UNITED STATES
NUCLEAR REGULATORY COMMISSION
WASHINGTON, D.C. 20555-0001

SUBJECT: PALISADES NUCLEAR PLANT- STAFF ASSESSMENT OF INFORMATION PROVIDED PURSUANT TO TITLE 10 OF THE *CODE OF FEDERAL REGULATIONS* PART 50, SECTION 50.54(f), SEISMIC HAZARD REEVALUATIONS RELATING TO RECOMMENDATION 2.1 OF THE NEAR-TERM TASK FORCE REVIEW OF INSIGHTS FROM THE FUKUSHIMA DAI-ICHI ACCIDENT (TAC NO. MF3786)

STAFF ASSESSMENT BY THE OFFICE OF NUCLEAR REACTOR REGULATION

PALISADES NUCLEAR PLANT

Figure 3.3-1 Plot of Staff's and Licensee's Base Case Shear-Wave Velocity Profiles. Shallow and Deep Refer to Reference rock Depths of 148 ft (45 m) and 3,238 ft (987 m), Respectively, for the Palisades Site

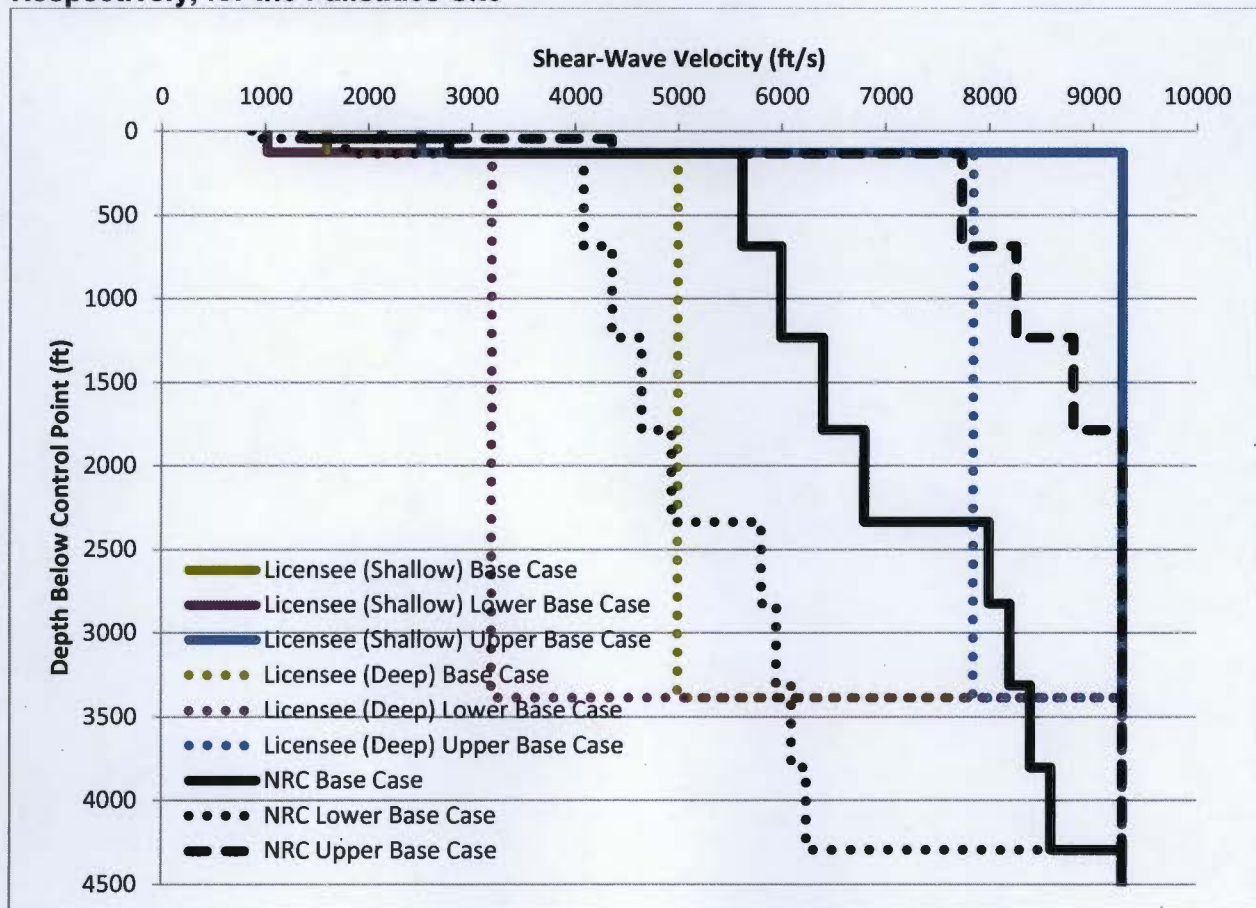
Following guidance provided in the SPID for sites with little at-site information, the staff independently determined a best-estimate and upper and lower base case profiles using guidance provided in the SPID and information provided in the Palisades UFSAR, the Donald C. Cook UFSAR, and literature sources. The staff modeled the upper 45 ft (14 m) of the profile as very dense dune sands and silty sands with a best-estimate shear-wave velocity of 1,360 ft/s (415 m/s). Below the sand layers, the staff modeled 90 ft (27 m) of glacial till with a best-estimate shear-wave velocity of 2,728 ft/s (831 m/s) overlying the sedimentary rocks, which have a best-estimate shear-wave velocity of 5,620 ft/s (1,713 m/s). Due to the lack of detailed stratigraphy and geophysical data, the staff assumed a shear-wave velocity gradient of 0.7 ft/s/ft for the sedimentary rock section and based its best-estimate shear-wave velocities on the General Atomic Site Parameter Study (Leeds, 1974). The staff used a natural log standard deviation of 0.35 to calculate upper and lower base-case profiles in the soil layers and a natural log standard deviation of 0.25 to calculate upper and lower base-case profiles in the rock layers. Staff used information provided in Fisher, et al. (1988) to determine a best-estimate depth to reference rock of 4,295 ft (1,309 m). Figure 3.3-1 of this staff assessment shows a comparison of the six velocity profiles developed by the licensee with the three developed by the staff. The profiles developed by the licensee are more heavily weighted towards higher velocities because three of the six profiles have shallow depths to reference rock. With the exception of the sand layers, the velocity profiles developed by the staff are higher than those developed by the licensee for reference rock located at the base of the sedimentary section. The staff randomized the depth to reference rock by ± 15 percent to account for additional uncertainty.

Similar to the approach used by the licensee, the staff assumed both linear and non-linear behavior for the materials beneath the Palisades site in response to the range of input ground motions. The staff developed two damping profiles that incorporate different degrees of non-linearity. The staff used the same damping curves as the licensee when developing the soil profile. However, for the rock layers, the staff assumed that the rock would behave linearly under all loading levels and assumed a constant damping value of 1.25 percent. The staff weighted each of these alternatives equally in the site response analysis.

To determine kappa for its three profiles, the staff used the low strain damping values, shear wave velocities, and layer thicknesses for each geologic layer to arrive at a value of 0.022, 0.028, and 0.012 sec, for the best-estimate, lower, and upper base case velocity profiles, respectively. These values include the 0.006 sec contribution from the reference rock. To model the uncertainty in the kappa values determined in the staff's analysis, the staff used a natural log standard deviation of 0.15 to calculate lower and upper values of kappa for each profile. This approach resulted in nine kappa values for use in the site response analysis, which range from 0.01 to 0.034 sec. Based on staff's confirmatory calculations of the licensee's inputs, kappa values for the profile with reference rock located at the base of the sedimentary section should be 0.026, 0.019, and 0.038 for the best-estimate, upper, and lower base case profile respectively rather than the reported 0.013, 0.019, and 0.038 sec. Staff's confirmatory analysis found that the licensee used the correct values and the reported value of 0.013 sec for this for the best-estimate profile was a typographical error.

Figure 3.3- 1 Plot Comparing the Staff's and the Licensee's Median Amplification Functions and Uncertainties for the Palisades site.

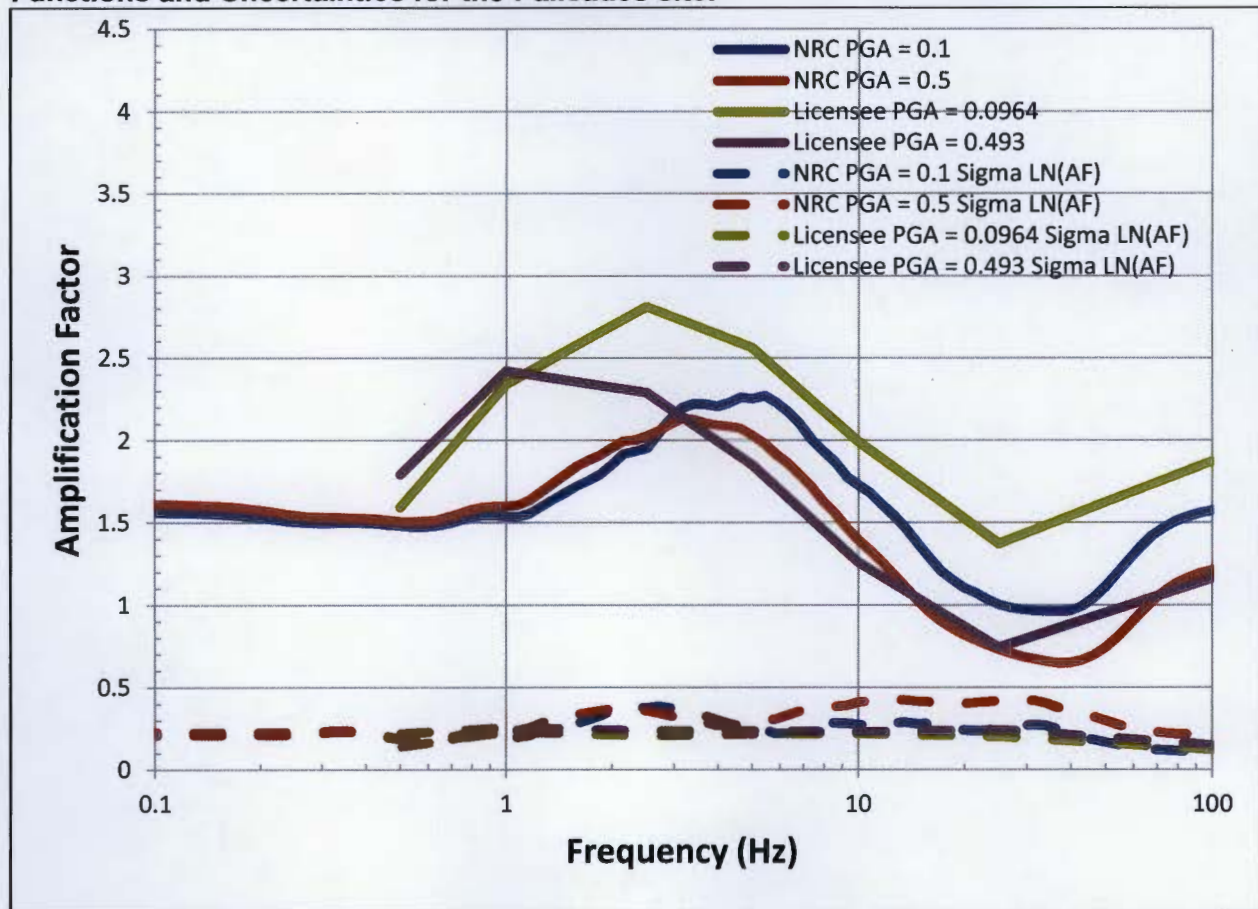
Figure 3.3-2 of this assessment shows a comparison on the staff's and the licensee's median site amplification functions and associated uncertainties (± 1 standard deviation) for two of the eleven input loading levels. Peaks in amplification functions occur between approximately 1 and 5 Hz in

both staff and licensee curves. Differences in the amplification functions developed by the staff and licensee are due to the licensee's use of six profiles, as described above, with three of the six profiles having reference rock directly beneath the soil layers.

Figure 3.3-2 Plot Comparing the Staff's and the Licensee's Mean Control Point Hazard Curves at a Variety of Frequencies for the Palisades site

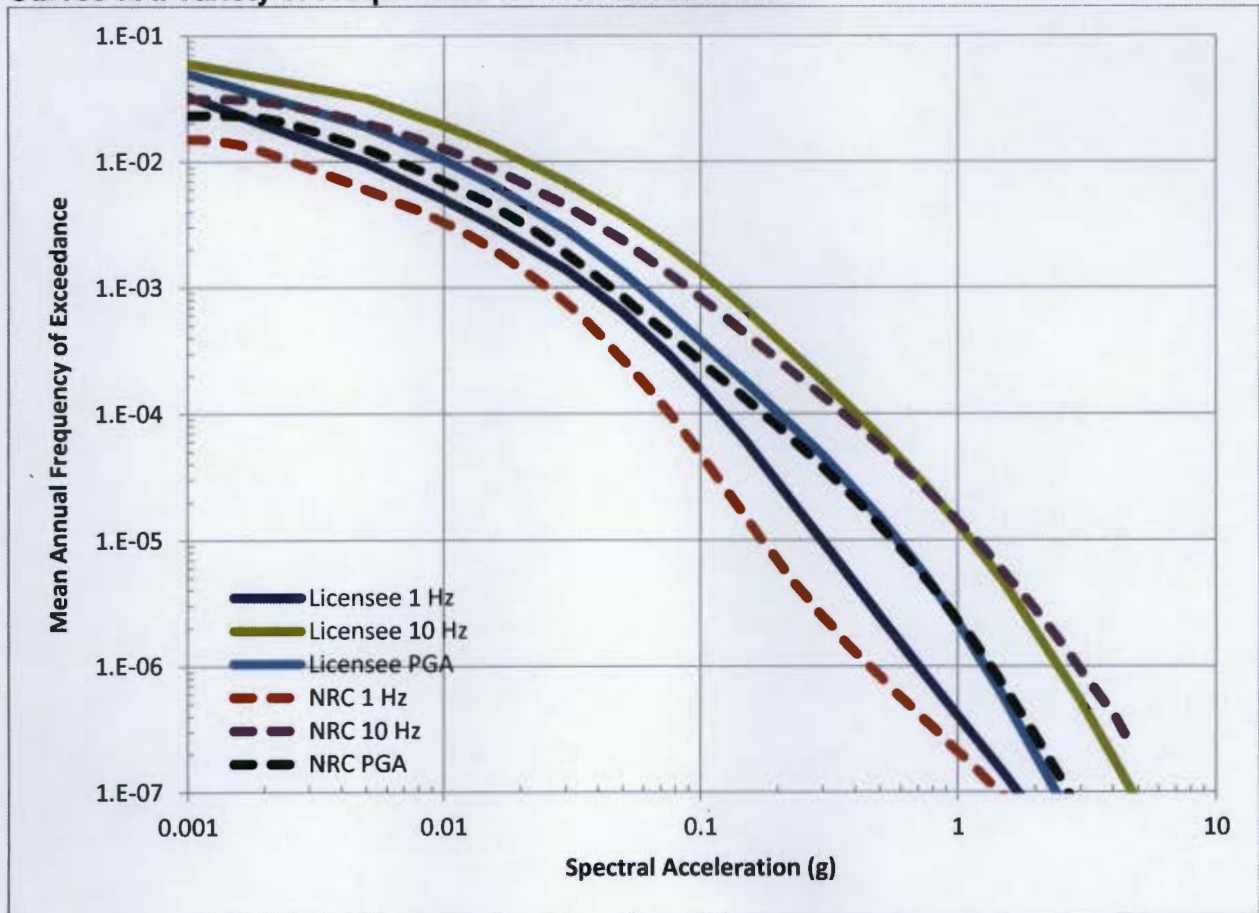
The licensee's approach to modeling the subsurface rock properties and their uncertainty results in higher amplification factors at low and high frequencies compared to those developed by the staff. As shown in Figure 3.3-3 of this assessment, these differences in site response analysis have a moderate impact on the control point seismic hazard curves and the resulting GMRS as discussed below. Specifically, hazard curves developed by the licensee are higher than those developed by the staff at 1.0 Hz, but consistent at other frequencies. These differences are the result of differences in site response analysis. Appendix B of the SPID provides guidance for performing site response analyses, including capturing the uncertainty for sites with less subsurface data; however, the guidance is neither entirely prescriptive nor comprehensive. As such, alternative approaches in performing site response analyses, including the modeling of uncertainty, are acceptable for this application.

In summary, the staff concludes that the licensee's site response was conducted using present-day guidance and methodology, including the NRC-endorsed SPID. The staff performed independent calculations to confirm that the licensee's amplification factors and control point hazard curves adequately characterize the site response, including the uncertainty associated with the subsurface material properties, for the Palisades site.

Figure 3.4-1 Comparison of the Staff's GMRS with Licensee's GMRS and the SSE for the Palisades site

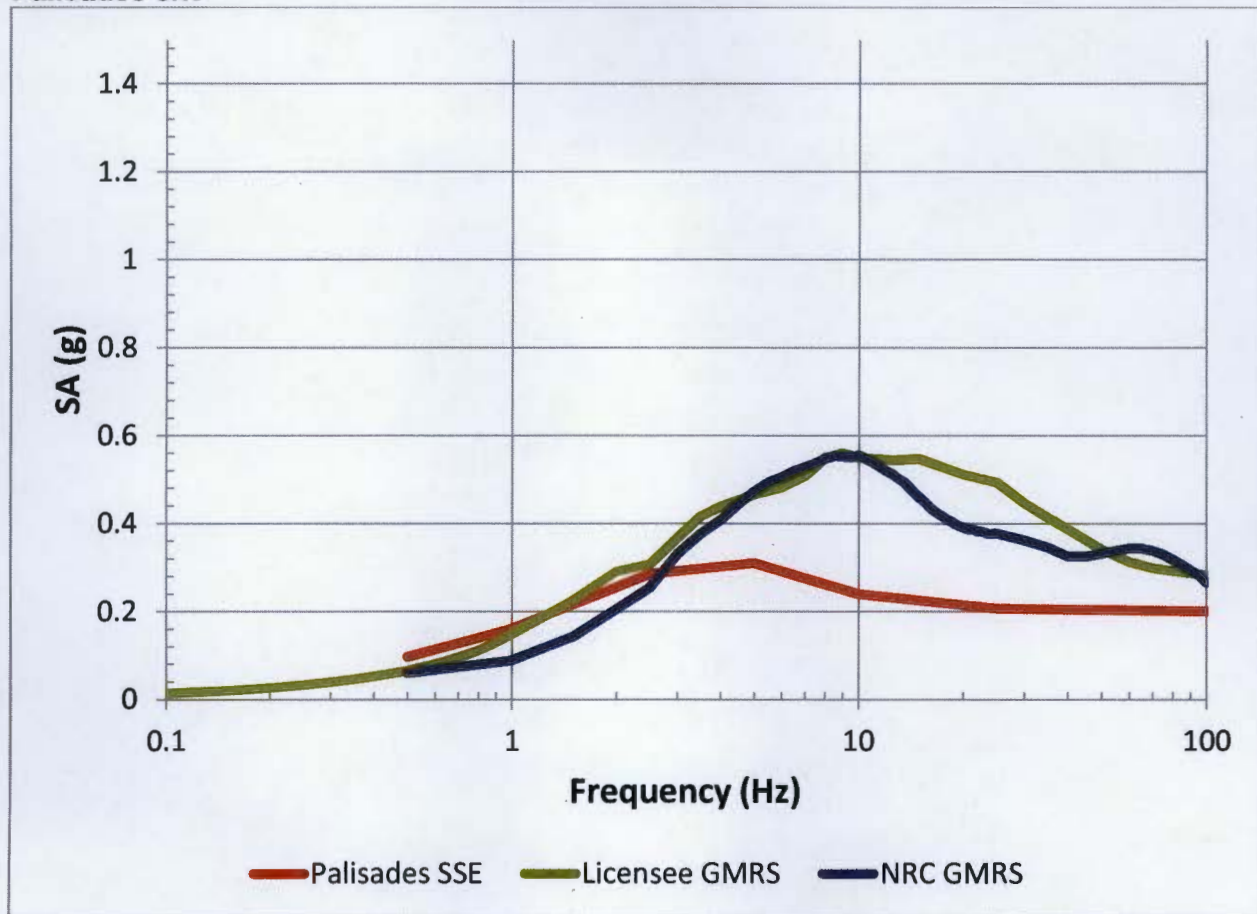
The staff independently calculated the 10^{-4} and 10^{-5} UHRs using the results of its confirmatory PSHA and site response analysis, as described in Sections 3.2 and 3.3 of this staff assessment, respectively. Figure 3.4-1 of this assessment shows a comparison of the GMRS determined by the licensee to that determined by the staff.

As shown in Figure 3.4-1 of this assessment, the licensee's GMRS shape is generally similar to that calculated by the staff. At frequencies where the amplitude of the GMRS determined by the licensee is different from that determined by the staff, the licensee's generally exceeds that of the staff. These differences in GMRS are the result of differences in the site response analyses performed by the licensee and staff, as discussed in Section 3.3 above. The staff concludes that these differences are acceptable for this application because the licensee followed the guidance provided in the SPID with respect to both the PSHA and site response analysis for the Palisades site.

The staff confirms that the licensee used the present-day guidance and methodology outlined in RG 1.208 and the SPID to calculate the horizontal GMRS, as requested in the 50.54(f) letter. The staff performed both a PSHA and site response confirmatory analysis and achieved results consistent with the licensee's horizontal GMRS. As such, the staff concludes that the GMRS

determined by the licensee adequately characterizes the reevaluated hazard for the Palisades site. Therefore, this GMRS is suitable for use in subsequent evaluations and confirmations, as needed, for the licensee's response to the 50.54(f) letter, dated March 12, 2012.
